FINAL PLAT

FOX POINTE SECOND ADDITION

Re: S/D 95-74 - FOX POINTE SECOND ADDITION (Final Plat)

CASE NUMBER: S/D 95-74 FOX POINTE SECOND ADDITION

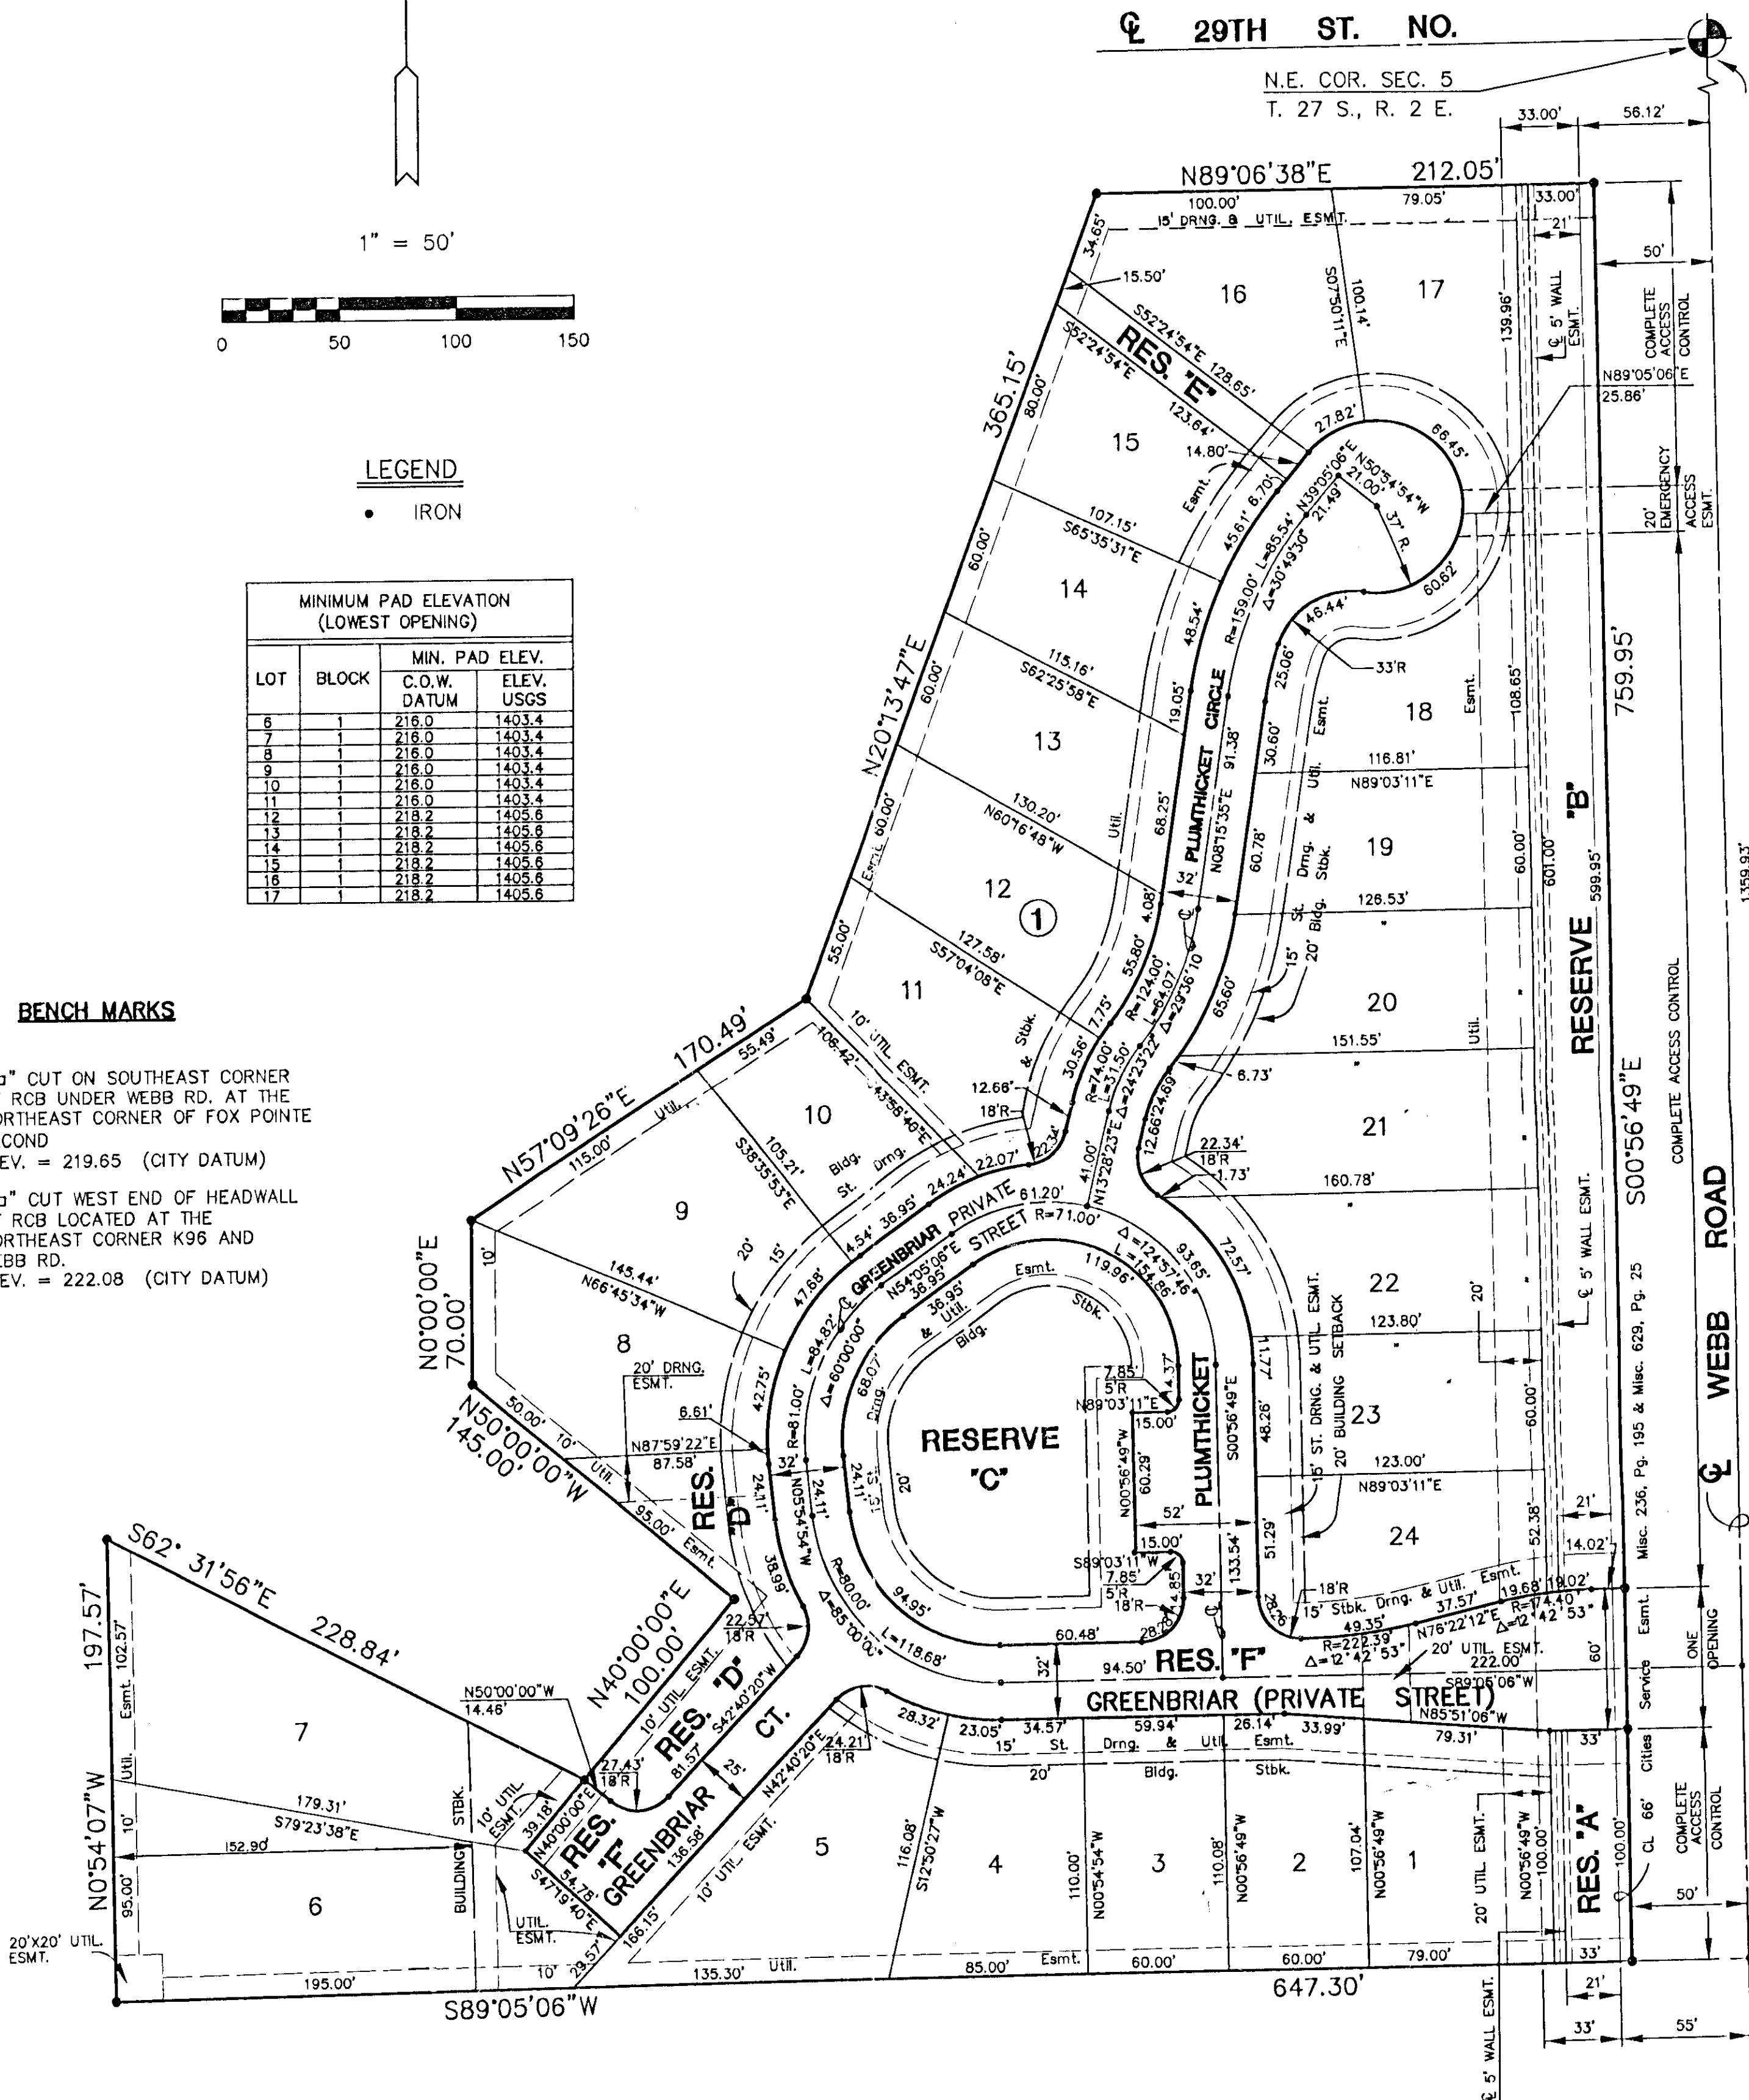
~~C.~~ *shown*
As this property is establishing minimum building pad elevations, the face of the final plat tracing shall reference the location and elevation of permanent on-site and off-site benchmarks. Section 5-402(N).

~~G.~~ On the final plat tracing, the surveyor's text shall be corrected to note that the drainage easement being vacated appears to have been recorded on Film 1131 not 131. *OK*

~~CC.~~ *extended as needed or more*
The final plat shall indicate the utility easements requested by K.G. & E.-Gas and K.G. & E.-Electric which are indicated on the enclosed "marked" copy of the plat.

~~DD.~~ *OK - Utility - they are now going to use an existing plat for above*
As indicated by City Engineering, the final plat tracing shall indicate an enlarged drainage easement along the plat's northern line. Further, an off-site drainage easement will be required and needs to be provided by separate instrument. This easement shall be submitted to Engineering for review, then to Planning for recording with the plat. *platted*
